Version 3

Center Display Buzz Or Ticking Sound

Supersedes 21-063, dated March 1, 2022, to revise the information highlighted in yellow.

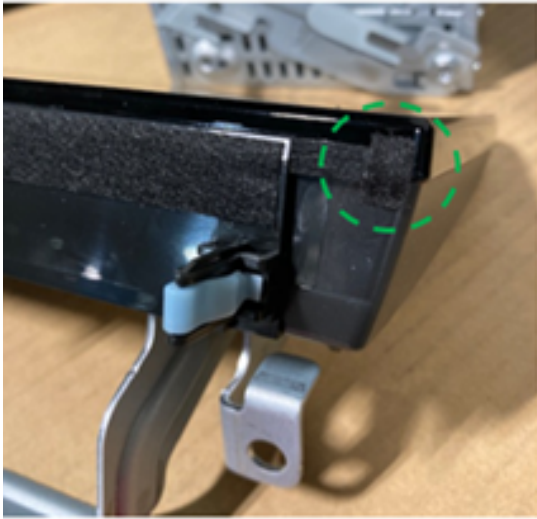
4. Apply 5 x 10 x 1 mm pieces of felt tape to the applicable screen as shown in the location on both sides, then install the center display unit.

NOTE: Make sure the felt is not visible after screen installation.
